TECHNICAL BULLETIN 017

April 2017

H90 AND H100/112 FLEXIBLE COUPLING FOR NHD AND NMT SERIES

Current Flexible Couplings NMT Series

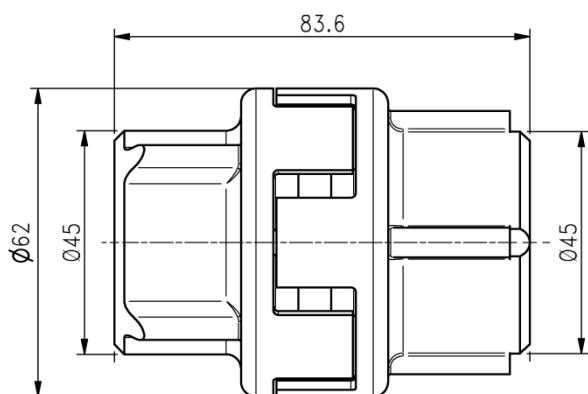
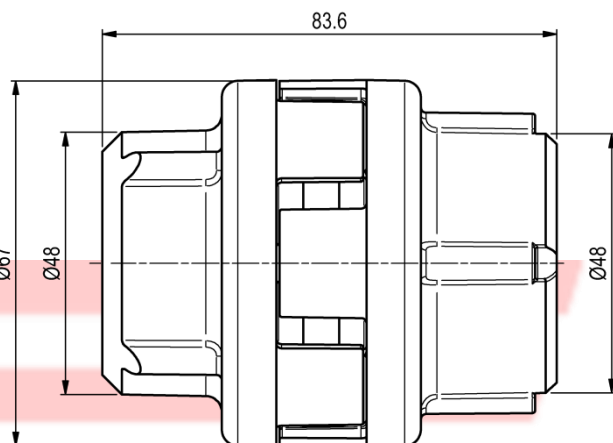
- Flexible couplings for NHD and NMT series have updated. They have been enlarged and reinforced.
- New versions are interchangeable with old ones, even in combination with current motor flanges.
- Part numbers are still the same: 1.099-542.0 and 1.099-543.0 for NHD series, 1.099-541.0 and 1.099-544.0 for NMT series

Attuali giunti flessibili serie NMT

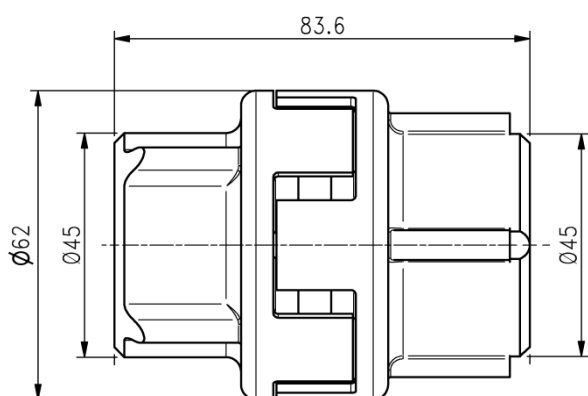
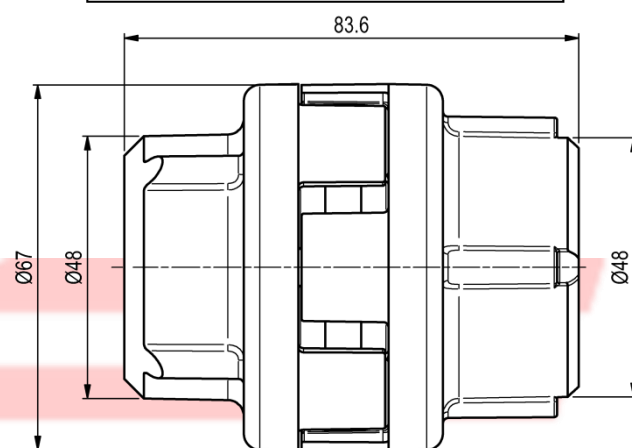
- Sono stati aggiornati i giunti flessibili per le serie NMT e NHD, ingrandendoli e rinforzandoli.
- Le nuove versioni sono intercambiabili con le attuali, anche in combinazione con le flange motore correnti.
- I codici d'ordine sono rimasti invariati: 1.099-542.0 e 1.099-543.0 per serie NHD , 1.099-541.0 e 1.099-544.0 per serie NMT.
